RMS Reference: SYD14/01251/09 (A13302279)
DP&E Ref: SSD 6801 – MOD_1

**SECTION 96 MODIFICATION FOR PROPOSED QUARRYWEST WAREHOUSE AND
DISTRIBUTION PROJECT WITHIN GREYSTANES SOUTHERN EMPLOYMENT LANDS**

**QUARRYWEST ESTATE – REVIEW OF DESIGN REQUIREMENTS FOR PROPOSED TRAFFIC
SIGNAL CONTROLLED INTERSECTION AT RECONCILIATION ROAD/DOLERITE
CLOSE/TURNBULL CLOSE, PEMULWUY**

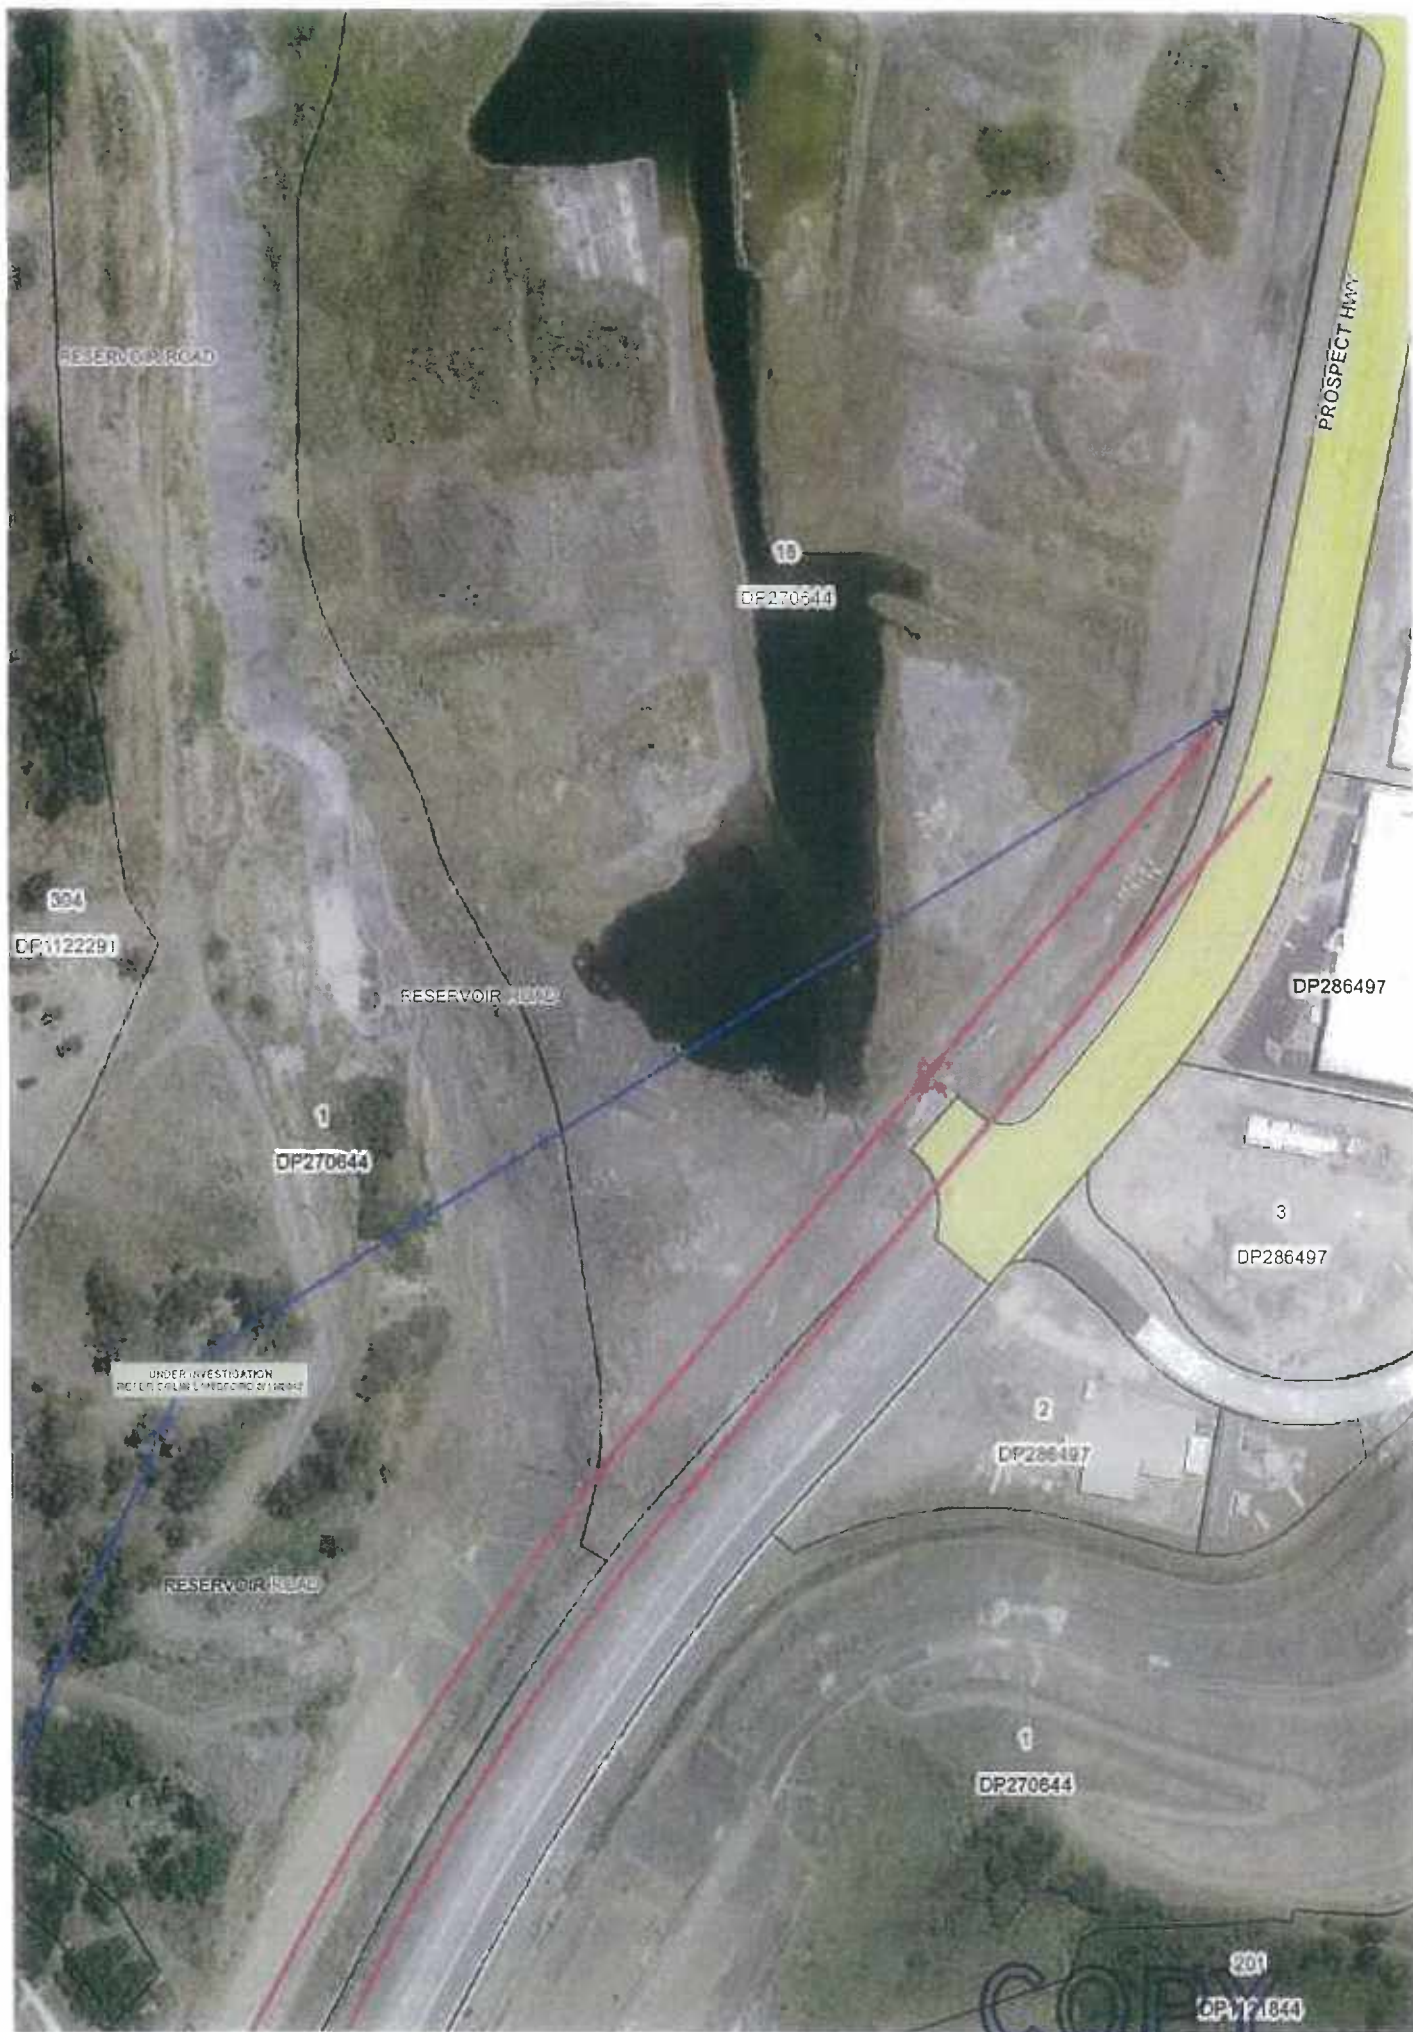
A strip of land has previously been dedicated as Public Road by private subdivision, along the Reconciliation Drive (Prospect Highway) frontage of the subject property, as shown by yellow colour on the attached Aerial – "X". All buildings and structures together with any improvements integral to the future use of the site are wholly within the freehold property (unlimited in height or depth), along the Prospect Highway boundary.
